YEAR 4 MONITORING REPORT

UT MILLERS CREEK

DMS Project ID No. 95719, Contract No. 5000, USACE Action ID No. SAW-2013-00386

Re: NCDEQ – Division of Mitigation Services
UT Millers MY 4 Monitoring Report
UT to Millers Creek Draft Year 4 Monitoring Report
Cape Fear River Basin, CU 03030006, Duplin County, DMS Project No. 95719

Figure 2.1

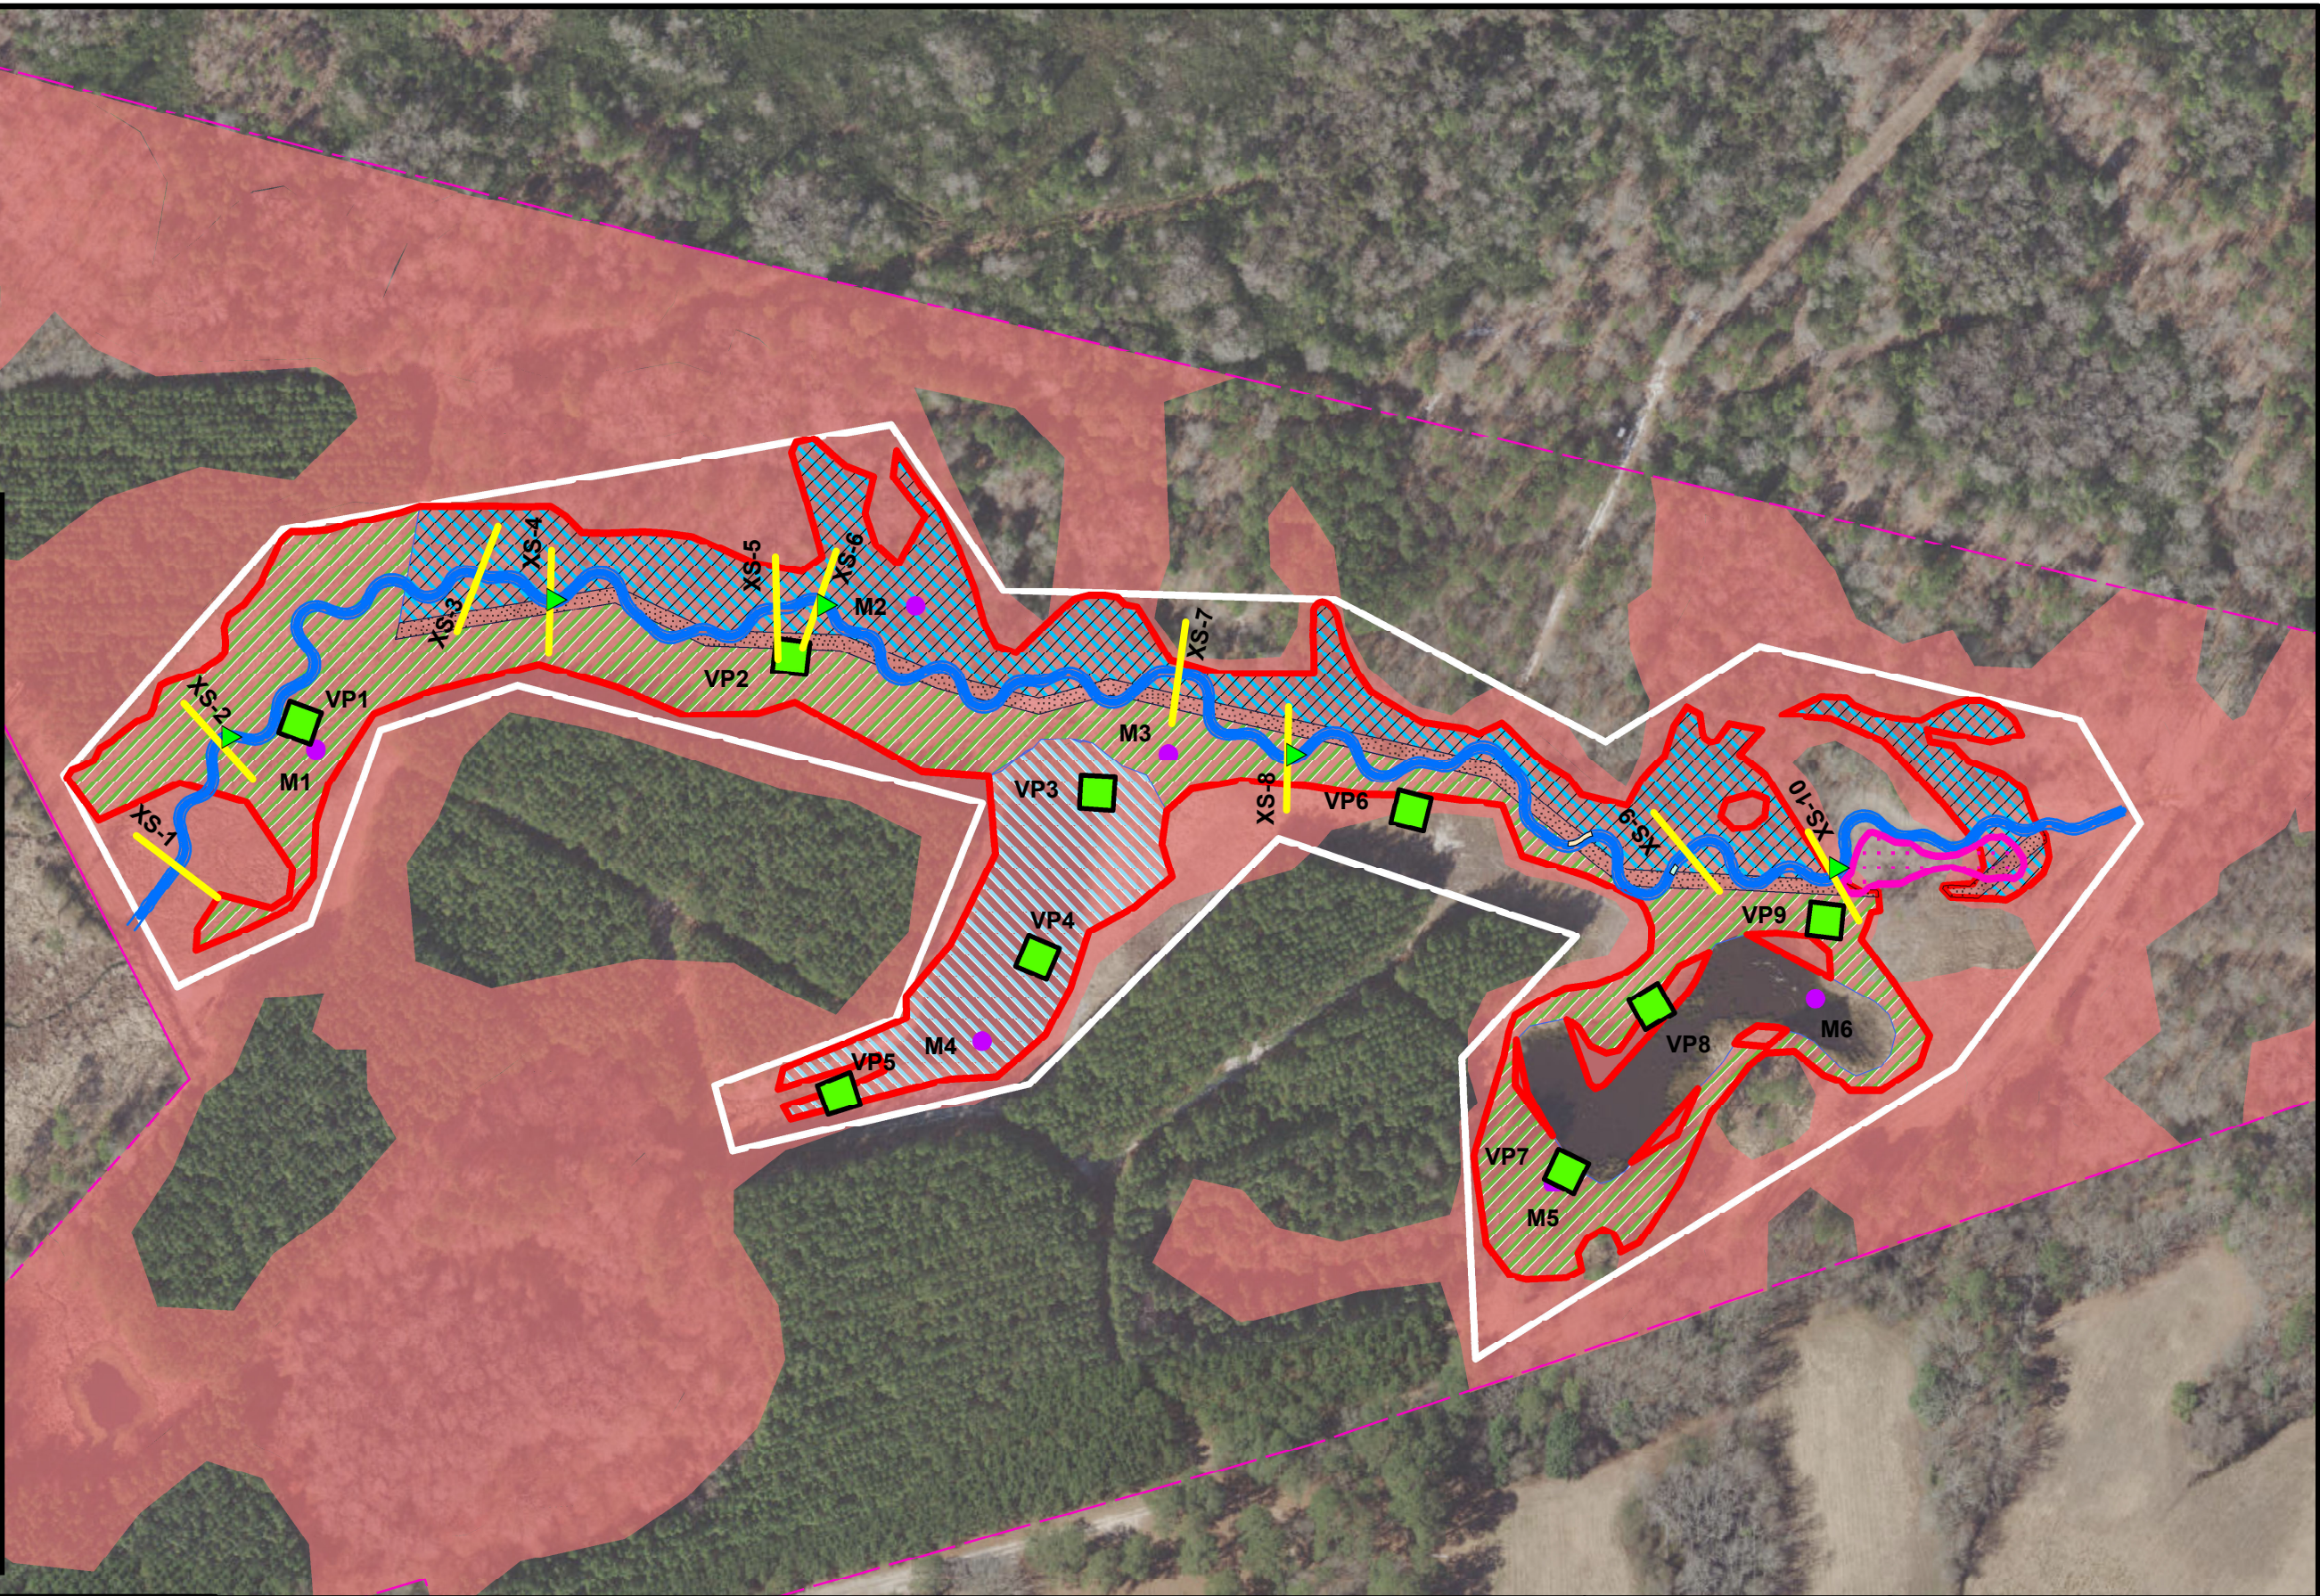
2. *CCPV, replace the pages 16-22 with a GIS rendered CCPV. It does not need to include engineering features. The gauges, vegetation plots, cross sections, and other monitoring features should be labeled and visible. Also, the assets should be apparent, along with any areas of concern (bank erosion, low vigor, etc areas). This should be a one-page map that is easy to understand similar to the one the IRT requested at credit release (I'm attaching it). Make sure that the headwater wetland is depicted separately on this map.*

4. *Page 3, Visual Vegetation Assessment- this section describes a lot of low stem density and bare areas that were not called out on previous reports, what has changed? During our site walk, I did not notice this extent of vegetative concern. Additionally, there is a successful vegetation plot in the middle of one section which does not make sense (VP6). Please*

evaluate if this shape matches the area on the ground of low stem density and revise CCPV, and table 6 accordingly.

5. *Page 3, Visual Stream Assessment- the next paragraph describes "holes" near the soil lifts? Would these features be better described as surficial scour, eroded depressions, or do they actually tunnel through? If these are just storm flow features where water is moving around roots, they may not be valuable to mention. The cataloging threshold for a channel the size of UT Miller (<3' bank height) is 10' of bank scour, slumping, or collapse. Do these areas meet this threshold? If not, remove and update table 5 accordingly.*

7. *Asset map- Figure 2- show the headwater area as separate on this map OR merge this with CCPV and delete it.*

The CCPV has been rendered in GIS. The assets have been included on this map and the figure for the asset map has been removed from the document.

The low stem density areas were reviewed and the CCPV was revised to show only one area of low stem density that meets the mapping threshold. Table 6 was also updated to reflect the revision.

The areas of erosion have been reviewed and it was determined that only two areas of bank erosion meet the mapping threshold of over 10'. The CCPV was updated to reflect these areas, as well as the narrative and Table 5.

The headwater area has been defined and is shown on the CCPV. The asset map has been deleted.
